MEMORANDUM

To: The Design Advisory Board
From: Mary O'Neil, AICP, Senior Planner *none*
RE: ZP 14-0499CA/MA; 237 North Winooski Avenue
Date: November 12, 2013

Overview: The former Dairy Queen, constructed in 1964, is proposed to be demolished and replaced with a mixed use building containing 28 residential units and approximately 1,500 sf of commercial space. Parking is proposed to be at grade behind streetfront commercial.

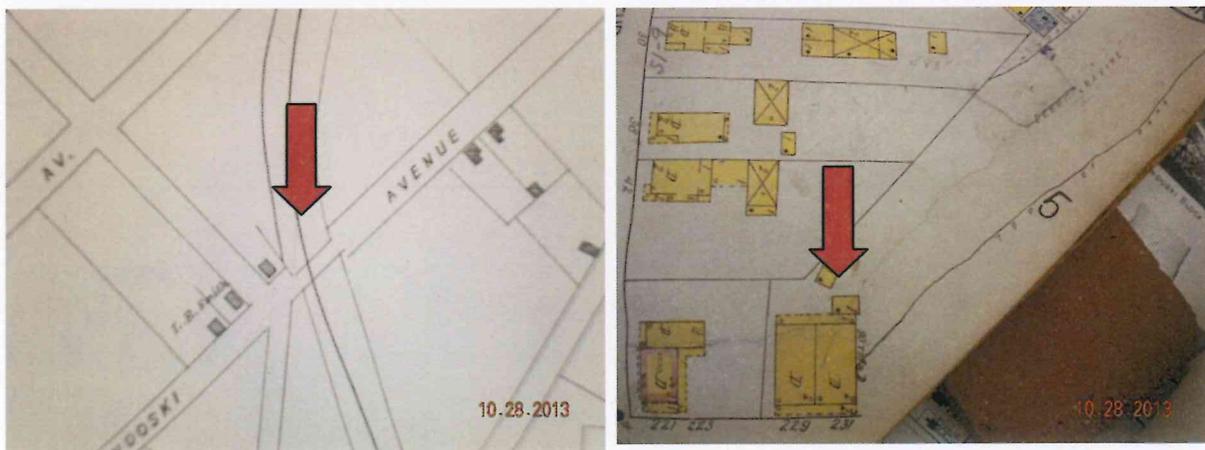
identified on the 1853 Presdee Edwards map (See above, left.) By 1918, a two story structure had been constructed at the westerly portion of the lot (See 1918 Sanborn map detail, above

right.) The ravine bank is illustrated both north and east. The eastly side of the parcel remains above the top of the embankment. The applicant has presented that the fill material includes coal ash from the Moran site; however the 1954 utility significantly post-dates this infill, and it is unlikely the provenance of the identified fill. In any event, Phase I and II assessments have been completed, and identify issues that will need to be addressed to assure compatibility with residential use.

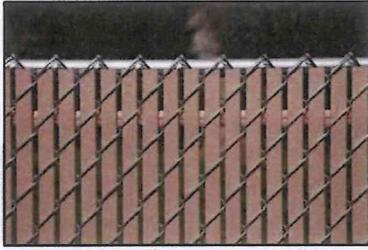
A dumpster is proposed at the rear of the structure. Proposed screening is chain link with privacy ribbons. While certainly sturdy as planned, the design leaves much to be desired for its aesthetic. The “slats” are soon broken and displaced, and the result is an unattractive, noisy cage. Here is an opportunity to incorporate a functional need within new development, rather than include an under-designed, ill performing -and unattractive structure in a significant development proposal. As situated, it is challenging to imagine how a commercial trash hauler would access the pen for traditional service.

While this cage may effectively screen the trash from view and prevent it from blowing around the site, design review anticipates a much more attractive, well-designed, well positioned and accessible enclosure to benefit the overall project.

DATE: SEP. 4, 2013
 SCALE: 1" = 10'
 PROJ. NO: 13203
 DRAWING NUMBER: **C1.0**

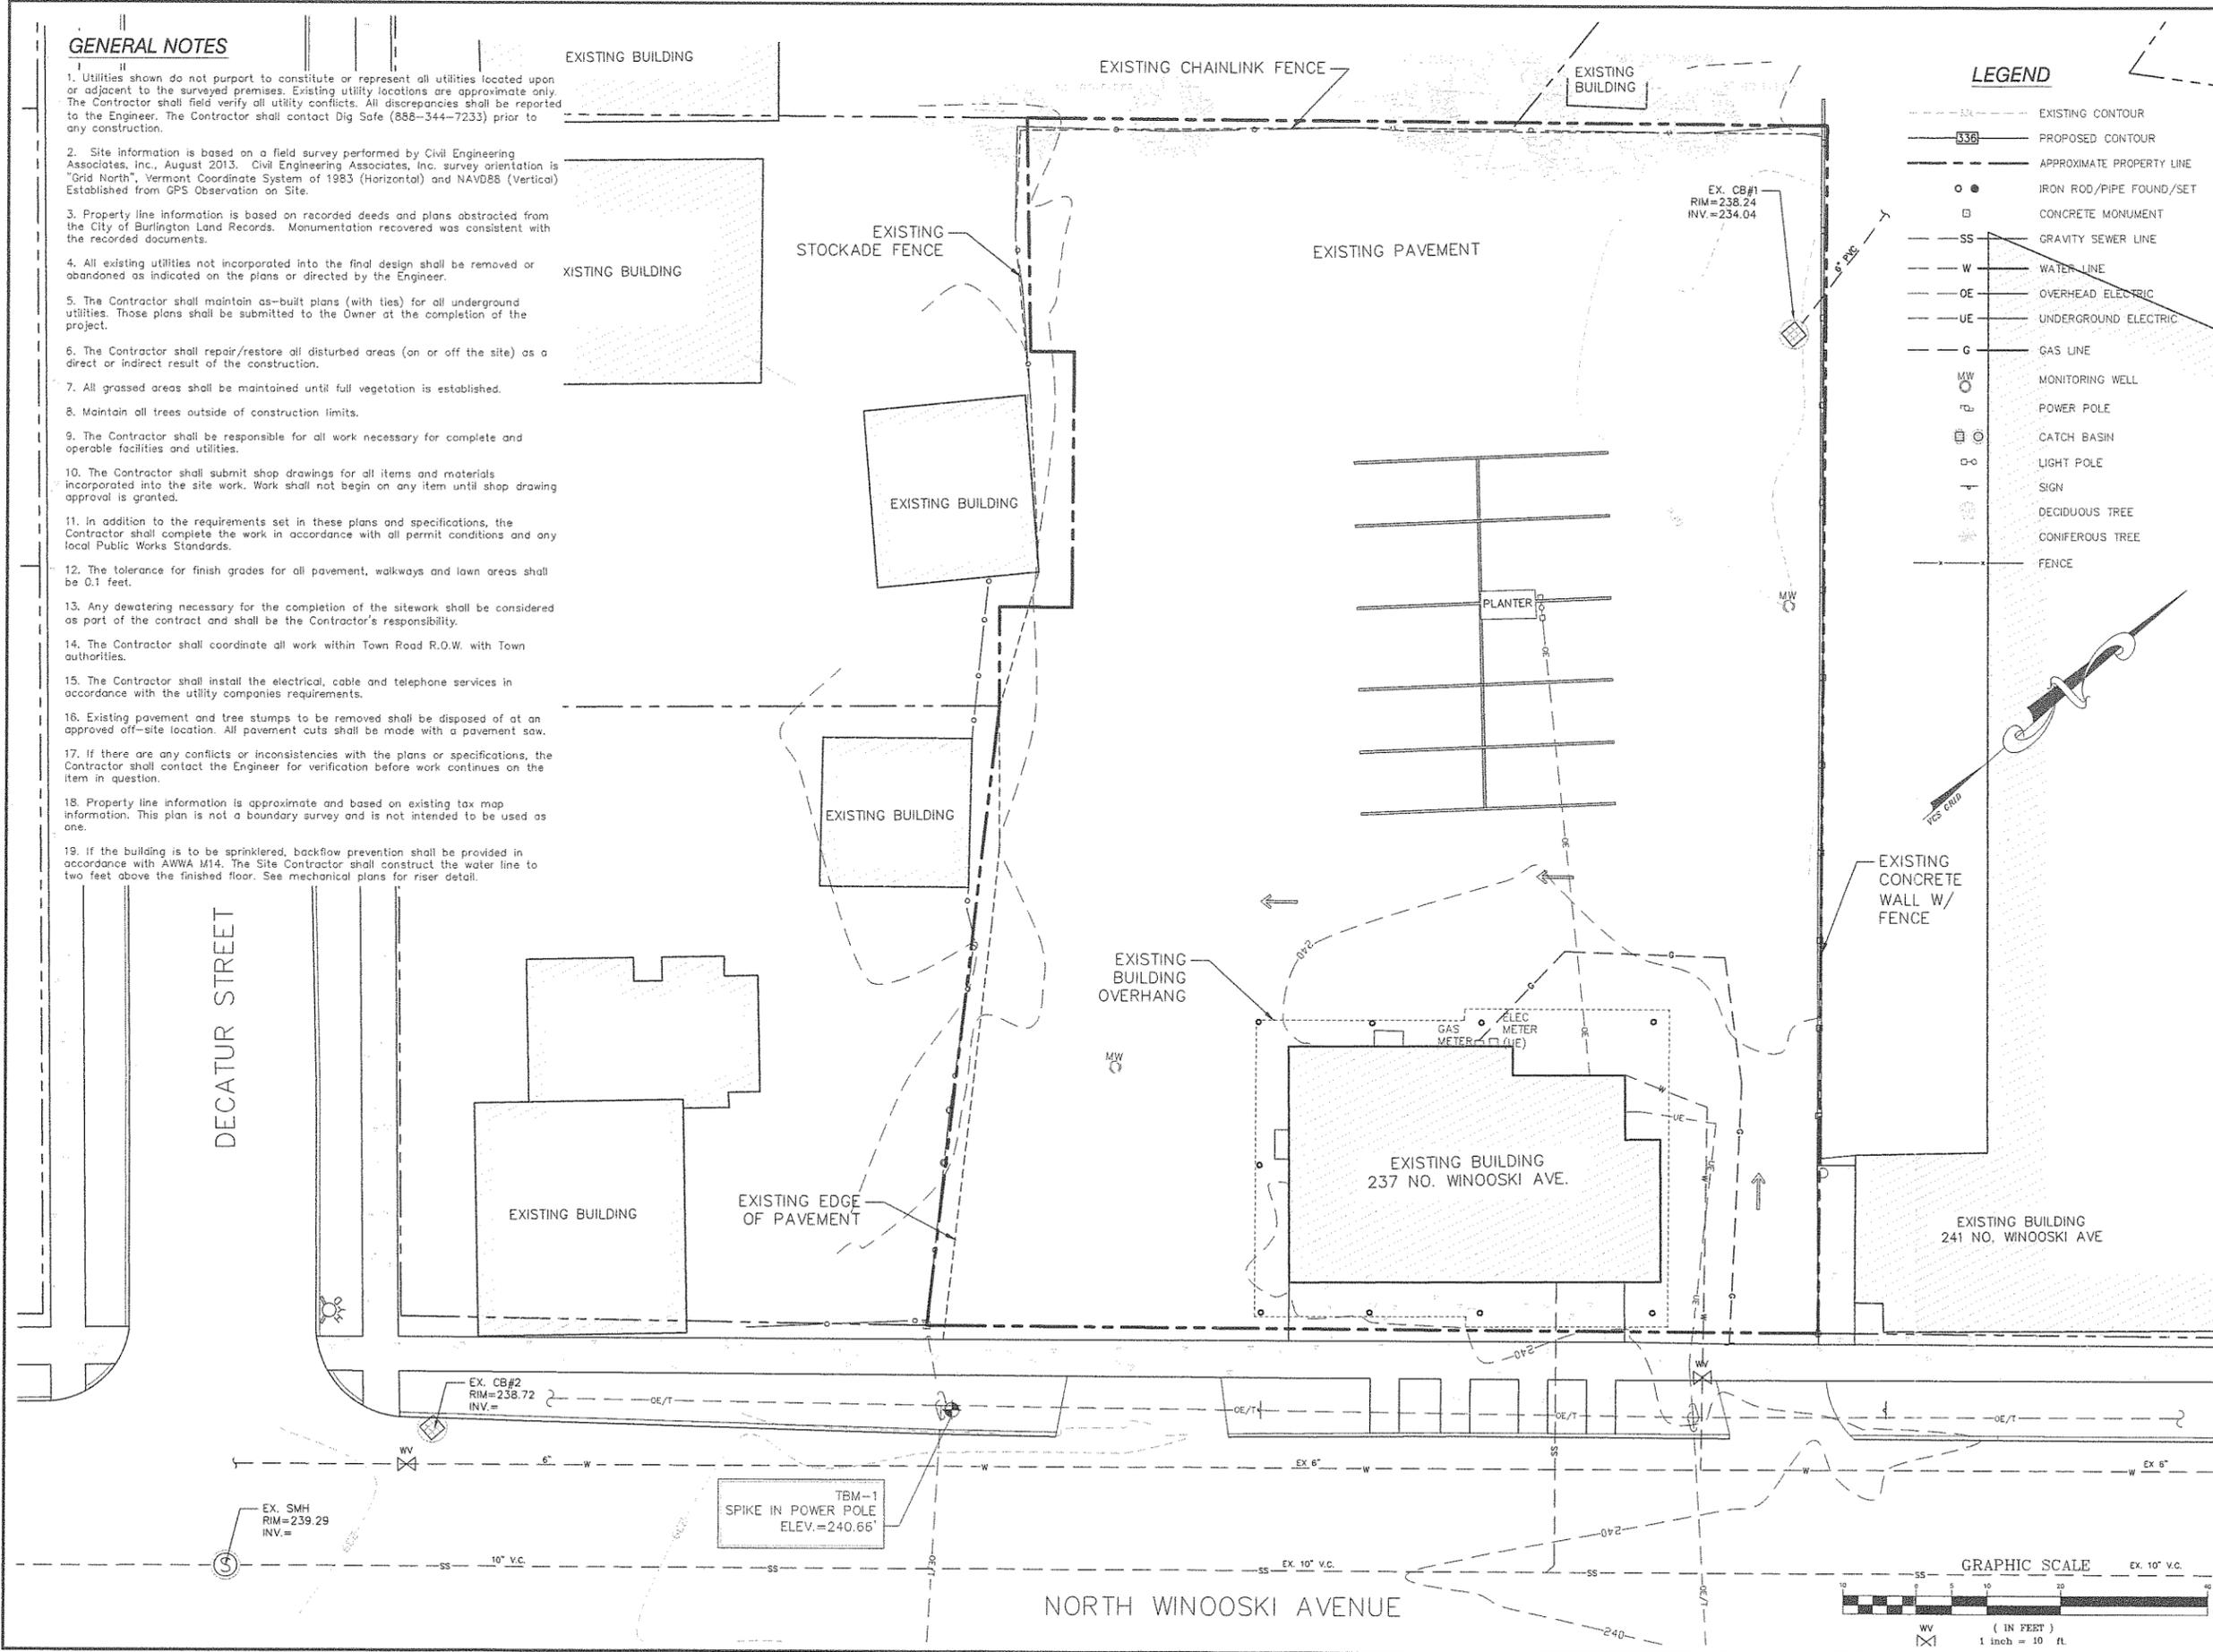
Plan C1.0, Existing conditions, identifies the presence of Monitoring Wells. A Phase I and II site assessments have been completed for this property. The applicant will be required to demonstrate compliance with any site treatment or mitigation as determined by the State of Vermont Department of Environmental Conservation (DEC.) Any modified site or other design plans resulting from the mitigation will need to be considered in the project review.

PROPOSED CONDITIONS SITE & UTILITY PLAN

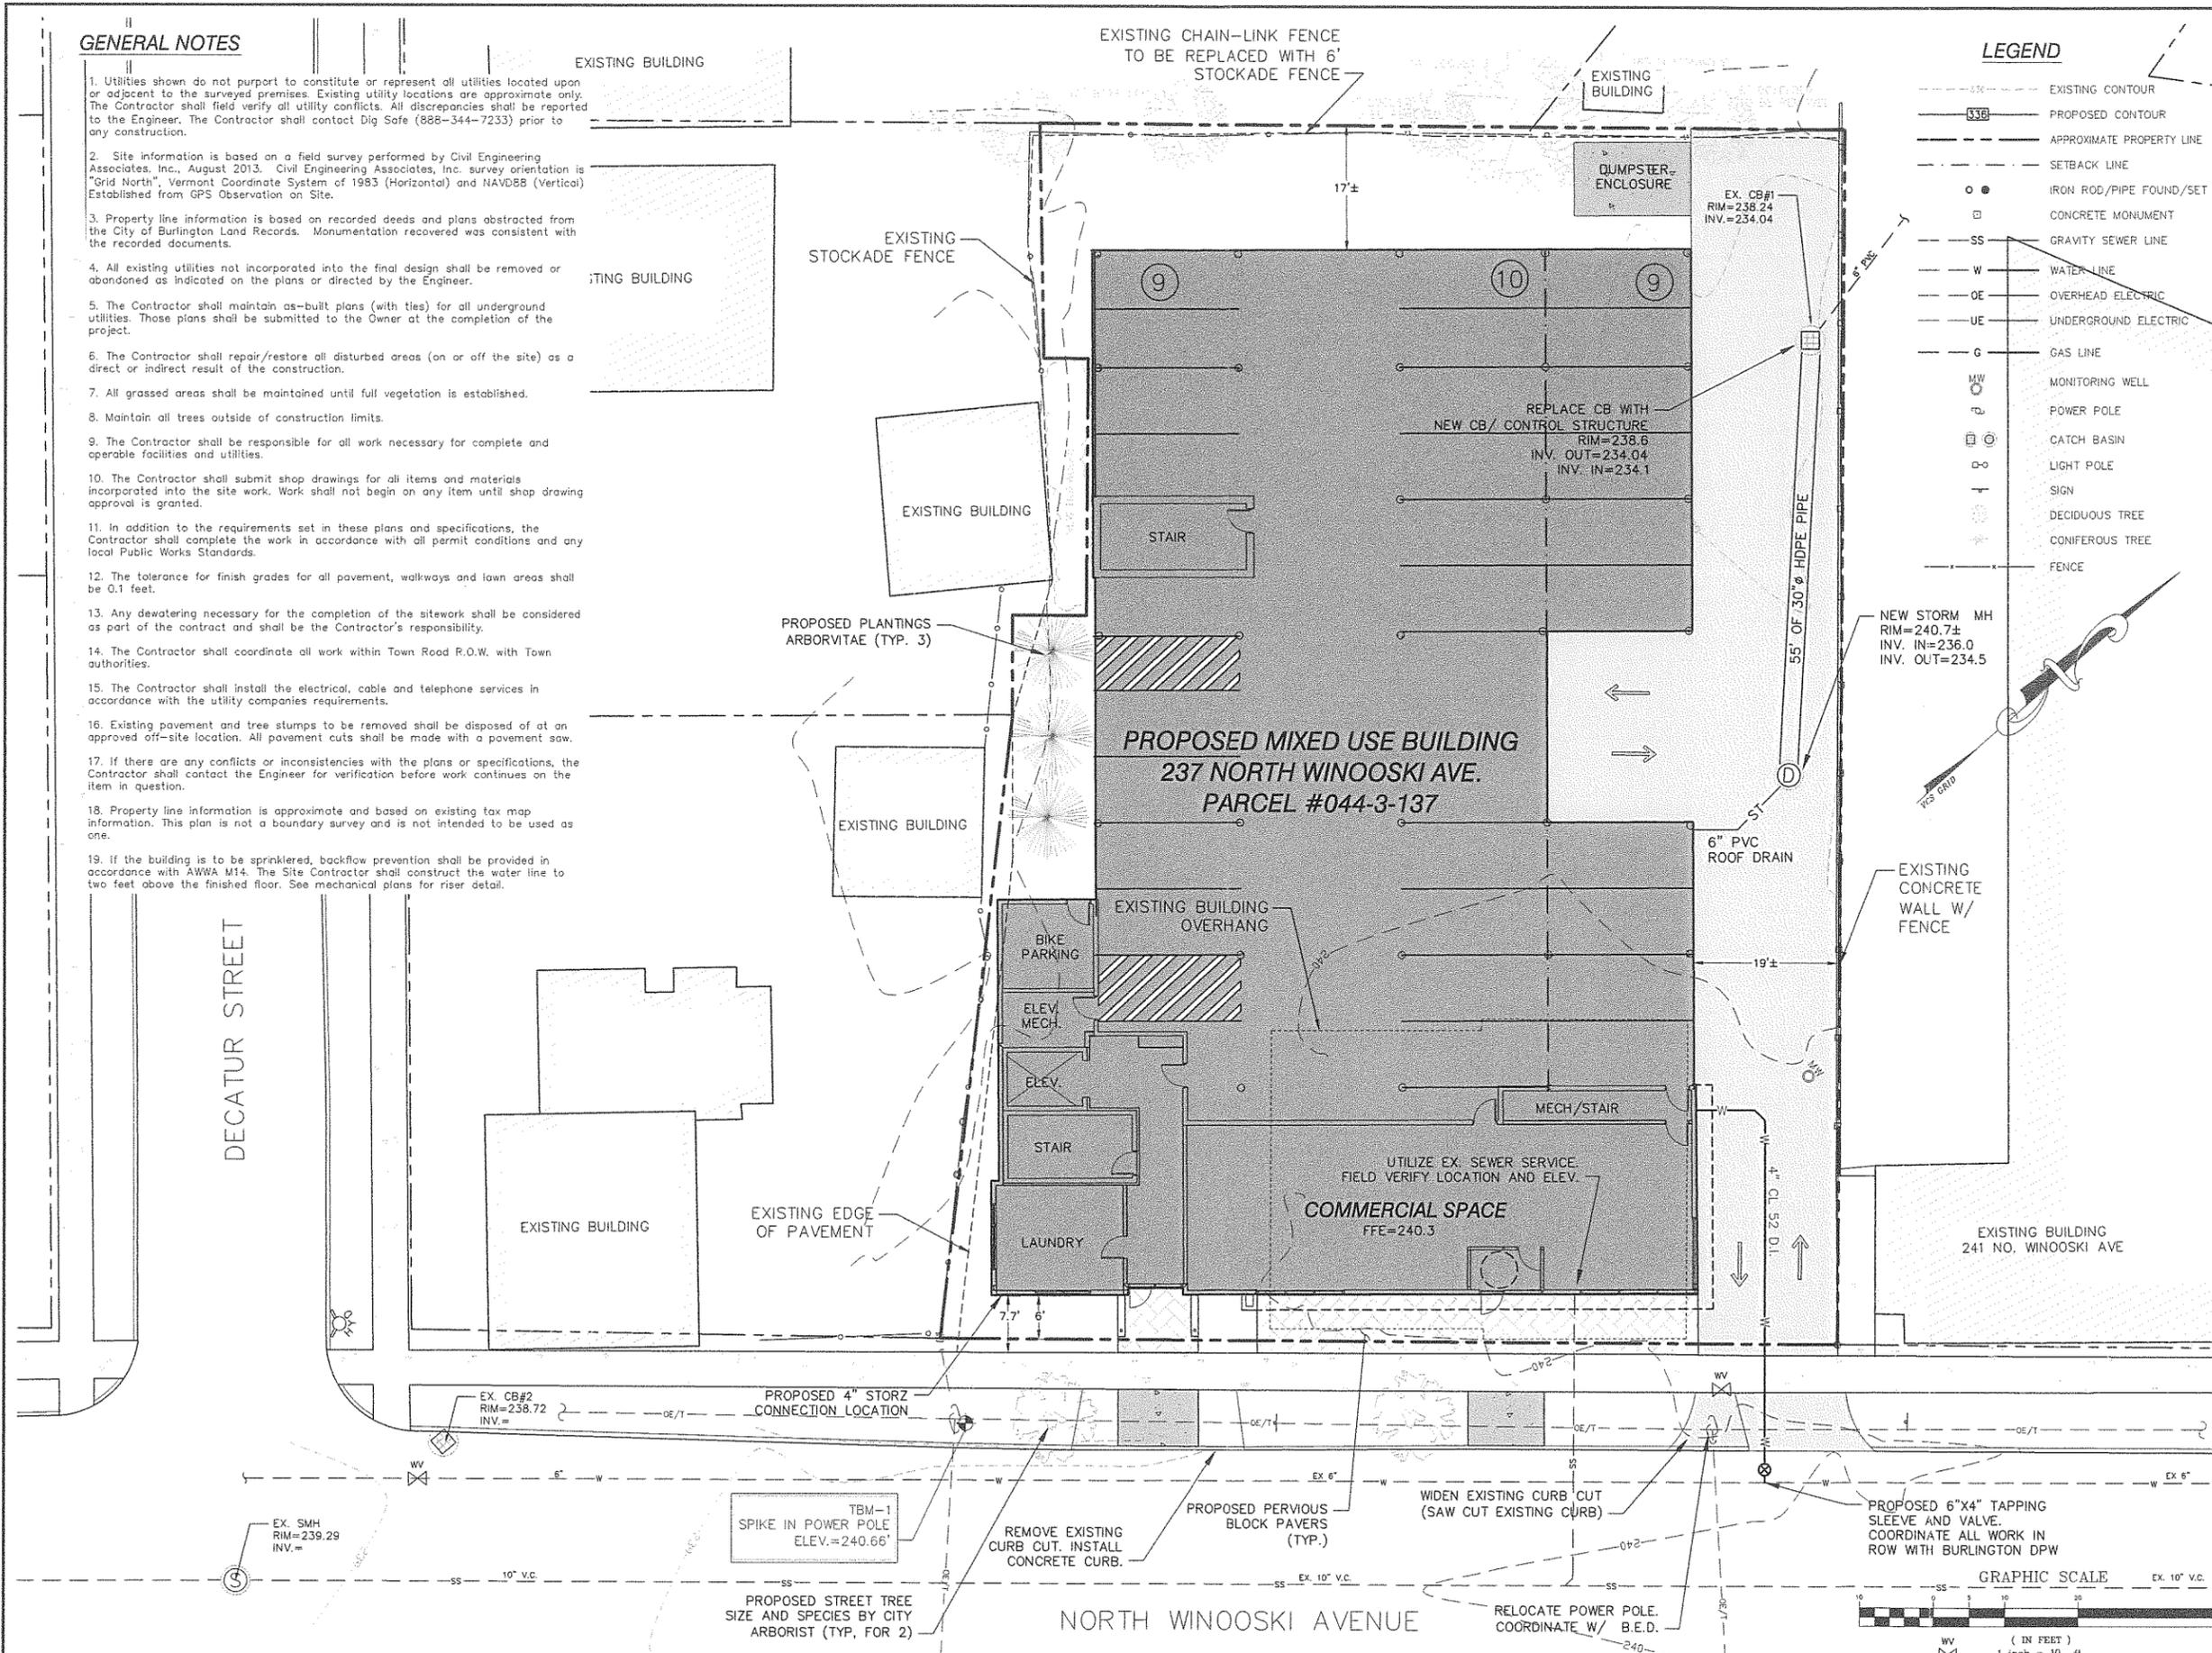
Plan C1.1 does not illustrate any proposed changes to the topography of the site.

Plan CC1.1 defines the elimination of an existing curb cut at the west, and widening the existing curb cut on the east. DPW traffic engineering staff requested a traffic brief verifying site distances and estimating traffic generated by site versus traffic from current use. It was suggested at that time that some further analysis may be appropriate. Sight lines for vehicles exiting the driveway also need to be considered.

The enclosed bike parking area is shown with an entrance door to the side yard (Plan C1.1) which does not appear to be independently accessible without navigating through vehicular parking, including a handicap parking space. Plan A2.1 shows a different access. Bike parking access shall be evaluated for its effectiveness. Short-term bicycle parking is provided within the parking garage, directly behind the commercial space. Other, public bicycle parking may be arranged, as necessary, with DPW and within the substantial public ROW. Further discussion, if warranted may be fruitful in this regard.

From Plan C1.1, the residential canopy appears to encroach within the public ROW. This shall be confirmed and required appropriate agreements shall be in place for any encroachment within the ROW.
